12.2	Planning Application P475/2023 for 8 Rawson Avenue, Sunshine
Directorate	City Futures
Director	Kelvin Walsh
Manager	Kristen Gilbert
Attachment(s)	1. Zoning map [12.2.1 - 1 page] 2. Aerial Photo [12.2.2 - 1 page] 3. Considered Plans [12.2.3 - 12 pages] 4. Detailed Assessment [12.2.4 - 36 pages] 5. Proposed Conditions [12.2.5 - 5 pages]

For Council to consider planning permit application P475/2023 for alterations to the existing dwelling and construction of two double storey dwellings to the rear at 8 Rawson Avenue, Sunshine, against the provisions of the Brimbank Planning Scheme.

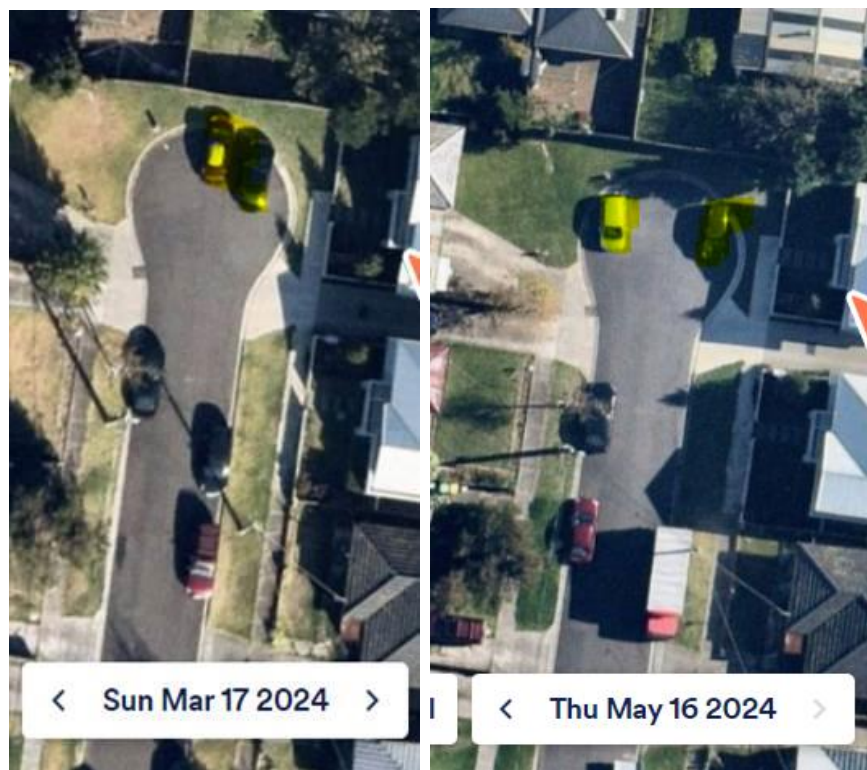
On street parking should be available for visitors rather than residents who ideally should park on their property. The images have not been taken on bin collection day, so it is unknown whether cars are parked in the cul de sac of these days.

The new double crossover proposed as part of the application at the top of the court will take away an area where residents are currently parking. It is likely they are parking there because there are currently

Following the Planning Forum where it was outlined by the objectors that the garbage truck currently reverses down Lorenz Street to collect the bins, and that all bins were collected from the northern side of the street, Planning Officers undertook discussions with Waste Services Officers who confirmed that this was the case. They advised that this was to prevent the garbage trucks having to reverse out onto Dulcie Street if they were unable to turn around at the end of Lorenz Street, because Dulcie Street tends to be a busy road.

Waste Services still advised that it is their preference that the court bowl itself was a "no standing" zone, but acknowledged that this was not imperative given that the trucks do not currently turn around in this area. Council's Traffic Engineers were also involved in this discussion and agreed that this was not imperative and that they were satisfied with the response from Waste Services.
